**Economic and Social Council**Distr.: General
15 January 2024

Economic Commission for Europe**Inland Transport Committee****Working Party on the Transport of Dangerous Goods****115th session**

**Proposals for amendments to annexes A and B of ADR:
Construction and approval of vehicles****Section 9.7.6 – Rear protection of vehicles****Transmitted by the Government of the United Kingdom****Summary*

Executive summary:	Proposals to clarify the requirements of ADR 9.7.6. in respect to the rear protection of vehicles and the minimum distance required between the rear of a tank and the rear of the bumper to ensure a uniform interpretation.
Action to be taken:	Amend ADR 9.7.6.
Related documents:	ECE/TRANS/WP.15/2020/5 and informal document INF.16 (108 th session) ECE/TRANS/WP.15/2021/7 and informal document INF.5 (109 th session) ECE/TRANS/WP.15/253 paragraphs 19-22 ECE/TRANS/WP.15/AC.1/158/Add.1 (item 9) ECE/TRANS/WP.15/2023/1 and informal document INF.9 (113 th session) ECE/TRANS/WP.15/262 ECE/TRANS/WP.15/2023/13 and informal document INF.22 (114 th session) ECE/TRANS/WP.15/264

Figure 1

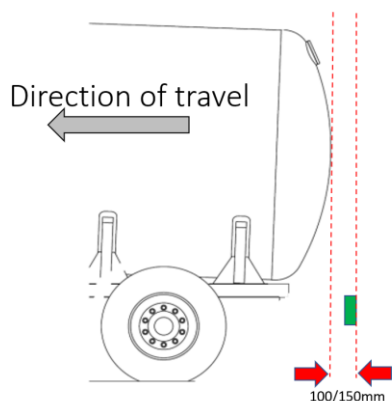
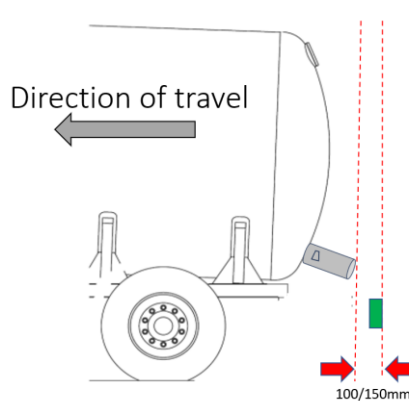
7. It would seem a strong case exists for all tanks, irrespective of their construction to have a bumper positioned at least [100/150] mm from the rearmost face of the bumper to the rearmost point of the tank (see figures 1 and 1 (a) below). This proposal would offer a consistent measurement across all types of tanks and give a clear interpretation regarding standards and approvals.

The rearmost face of the bumper shall be positioned at least [100/150mm] from the rearmost part of the tank (or of its projecting fittings in contact with the substance being carried). This shall be measured as specified in figures 1 and 1 (a).

Figure 2

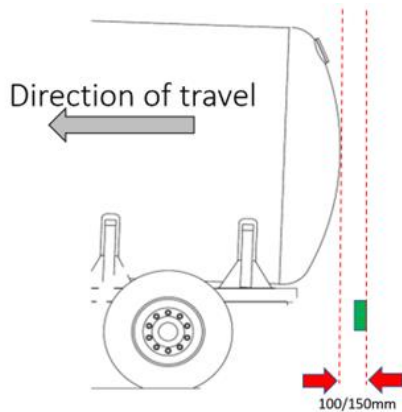
8. Alternatively, an equally strong case exists for the bumper position to be based on type of tank. The bumper should be positioned at least [100/150] mm from the rearmost part of the tank, but for tanks with additional protection by their design the distance may be reduced to at least [50] mm, provided the distance to the shell respects the minimum values given above (see figures 2 and 2 (a) below).

9.7.6.2.2 The bumper shall be so positioned on the vehicle that the distance from the rearmost face of the device (the rear most part of the vehicle) to the rear most part of the tank be at least [100/150mm] (see figure 2).

Figure 2 (a)

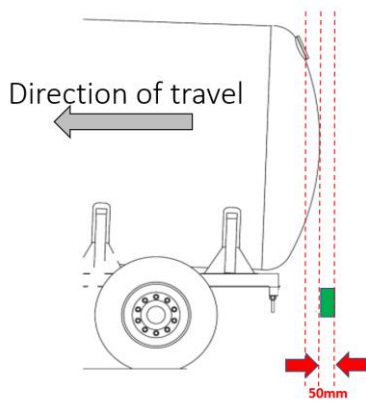
9.7.6.2.3 In case of tanks with double ends and tanks with thermal insulation [excluding tanks with vacuum insulation] the distance from the rear of the tank to the rearmost part of the bumper may be reduced to at least [50 mm] (see figure 2 (a)), provided the distance to the shell respects the value given in 9.7.6.2.2.
